**RE: Mister Car Wash
2161 Gibson Blvd SE
Grading & Drainage Plan
Engineer's Stamp Date: 11/17/22
Hydrology File: M15D021B**

**RE: Mister Car Wash #1394, 2161 Gibson Blvd SE, ABQ
Hydrology File: M15D021B**

COMMENT RESPONSE LETTER

GRADING & DRAINAGE
PLAN

SHEET NUMBER
C500

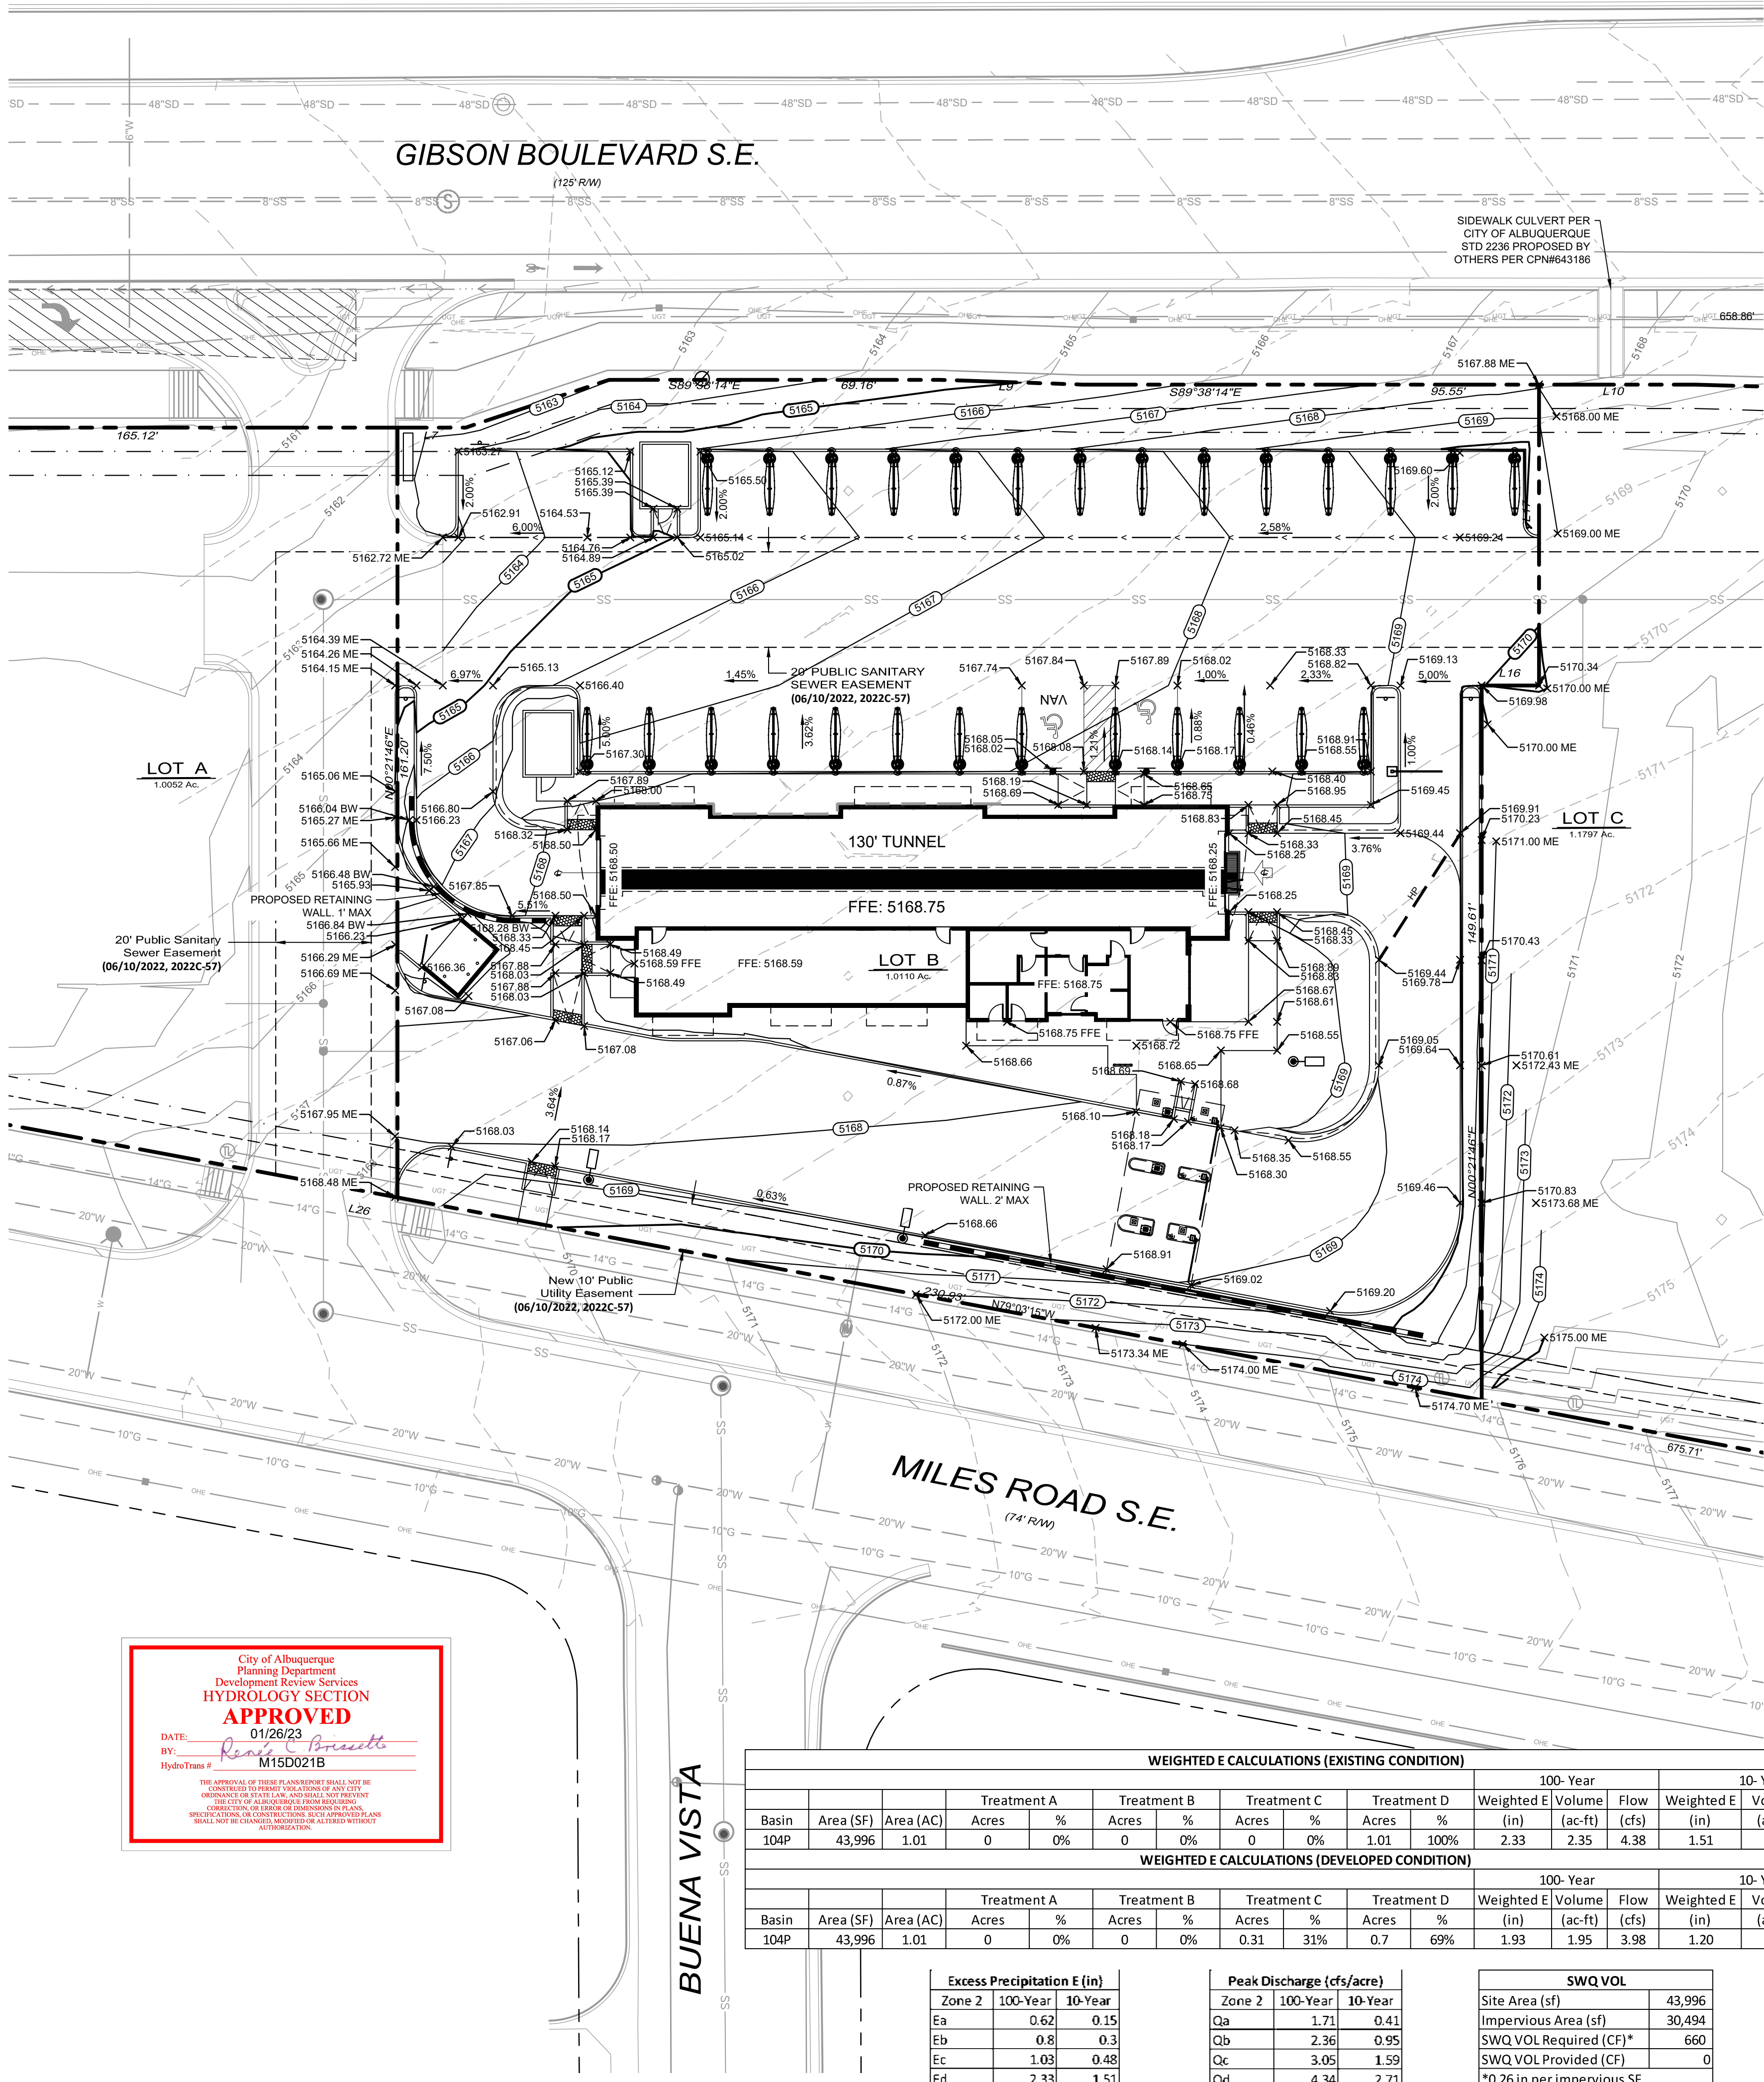
1. Per the DPM, the following must be on the Grading Plan. Please note the Grading Plan must be a stand-alone construction document.
 - a. Please provide a Vicinity Map. Typically, this is the Zone Atlas. This can be downloaded in pdf format from the City of Albuquerque's website.

- b. Please provide the Benchmark information (location, description and elevation) for the survey contour information provided.

- c. Please provide the FIRM Map and flood plain note with effective date.

- d. Please provide a legal Description of the property.

2. Please reference City of Albuquerque standard detail No. 2236 – Sidewalk Culvert with Steel Plate Top at the sidewalk culvert. (see comment below for location).

3. Please add the attached SO-19 Notes.

4. Please use the procedure for 40 acre and smaller basins as outlined in Development Process Manual (DPM) Article 6-2(a). Please provide both the existing conditions and proposed conditions for the 100 year-6 hour storm event.

5. Provide management onsite for the Stormwater Quality Volume (SWQV) in accordance with the Drainage Ordinance, § 14-5-2-6 (H) and the DPM Article 6-12 Stormwater Quality and Low-Impact Development for the sizing calculations. To calculate the required SWQV, multiply the impervious area draining to the SWQ pond by 0.42 inches for new development sites. Please show both the required and the provided volume.

6. The onsite drainage should be directed to the stormwater quality (SWQ) pond prior to leaving the site. Currently you have the SWQ pond on the high side of the site with little drainage going into it. Also, please show the top and bottom of the pond along with the volume for the pond. The pond also needs a spillway in the form of a sidewalk culvert at the SWQ water surface elevation on the pond side and match the existing gutter elevation in Gibson.

7. Please reference City of Albuquerque standard detail No. 2236 – Sidewalk Culvert with Steel Plate Top at the sidewalk culvert.

8. Please add either a concrete flume (channel) or a rock swale with curb cuts on either end so that the drainage can travel to the SWQ pond.

9. Please provide the weir calculations, per DPM Article 6-16(A), for the curb cuts and sidewalk culverts. A coefficient of 2.7 is typically used for the weir equation $Q = CLH^{2/3}$.

Response: This has been added to the plan sheet.

Response: Response: This has been added to the plan sheet.

Response: This has been added to the plan sheet.

Response: This has been added under the Introduction and Project Description information.

Response: We have added a note for the proposed culvert locations on adjacent property to be installed by the developer. No culvert is proposed in this location as the runoff sheet flows in drives or over the sidewalk.

Response: These have been added to the plan sheet.

Response: Existing and Proposed Condition 100 year – 6 hour flows have been added to the sheet.

Response: As this is a redevelopment site, we have provided the SWQV calculations based on 0.26 inches, and this has been added to the plan sheet.

Response: The SEC of the site and the area adjacent to the east side of the building flows into the SWQ area. The areas to the south and west sides of the building flows across landscape prior entering the paved areas and discharging to Gibson Blvd. There are numerous challenges to providing the SWQ area in the location suggested in the comments due to the sites grading, access drive, and parking demands. Please see attached waiver letter for remaining SWQ volume.

Response: Understood that this detail is to be used if culverts are required.

Response: This is the transformer pad location so a flume cannot be provided across the island behind the dumpster.

Response: The drainage sheet flows over the sidewalk or in the driveways to Gibson.
